Architect's Supplemental Instructions Addendum

Project: Samish Xwch'ángteng Development on 34th Street
Anacortes, WA

Addendum/ASI No.: Addendum 04
Date of Issuance: June 3rd, 2022

REVISION	DATE
100% BID SET	9/21/2021
ADDENDUM ¹	5/09/2022
ADDENDUM ²	5/23/2022
ADDENDUM ³	6/03/2022

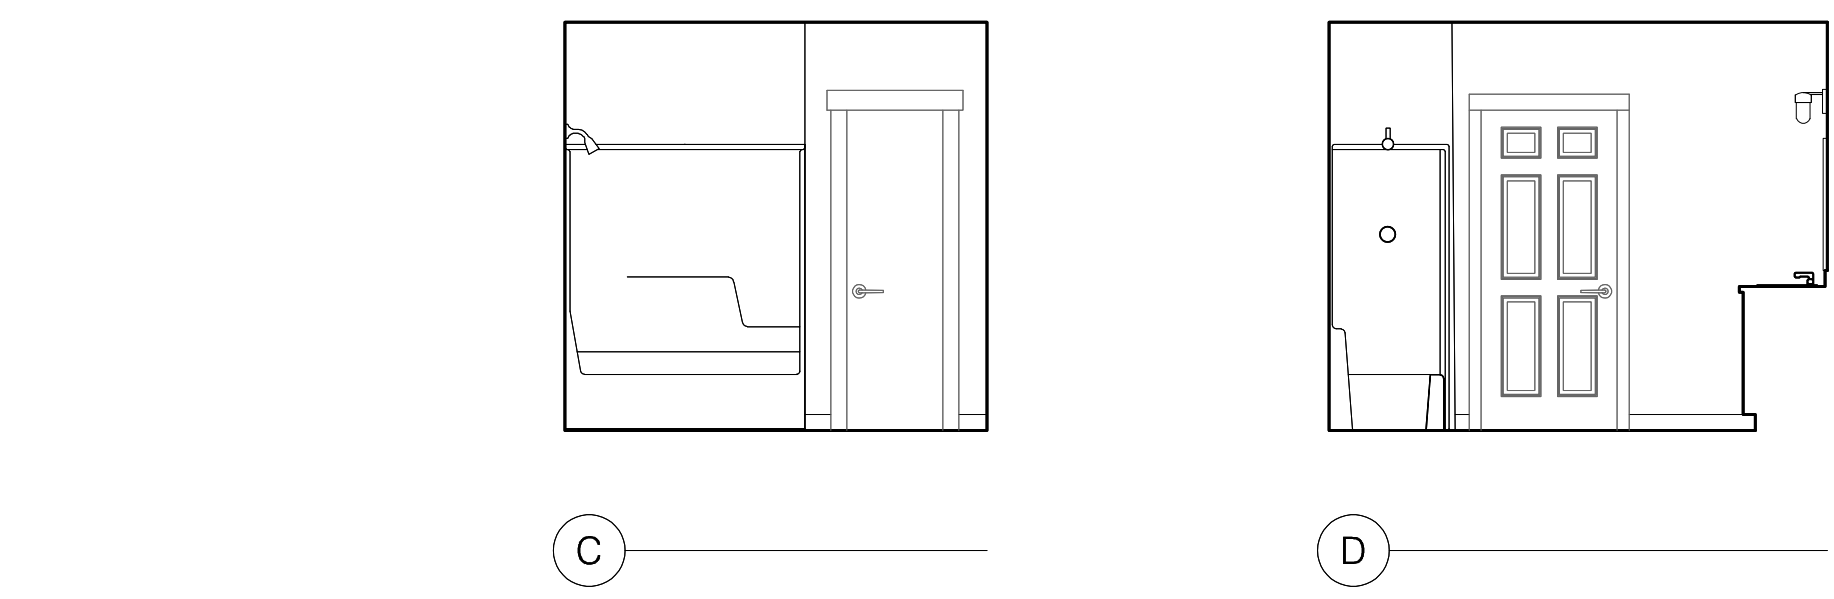
1. Sheet ATS: add [DEFERRED SUBMITTALS LIST](#)
2. A200, A201, A202, A203, A204, A300, A301, A302, A303, A304, A305 note #18 add [MAXIMUM 5 AIR CHANGES PER HOUR. A BLOWER DOOR TEST IS REQUIRED BY THE WASHINGTON STATE](#)

ENERGY CODE R402.4.1.2 TESTING FOR EACH HOUSING UNIT. TEST TO BE PAID AND
COORDINATED BY CONTRACTOR

- PROVIDE PASSIVE RADON SYSTEM PER MEP SHEETS & DETAIL 3/A402
- ALL INTERIOR PAINTS MUST COMPLY WITH GREEN SEAL STANDARDS FOR LOW VOC LIMITS
- BUILDING ENVELOPE TO HAVE AN AIR LEAKAGE RATING OF LESS THAN OR EQUAL TO 0.40 CFM/SQ.FT. MAXIMUM 5 AIR CHANGES PER HOUR. A BLOWER DOOR TEST IS REQUIRED BY THE WASHINGTON STATE ENERGY CODE R402.4.1.2 TESTING FOR EACH HOUSING UNIT. TEST TO BE PAID FOR AND COORDINATED BY CONTRACTOR.
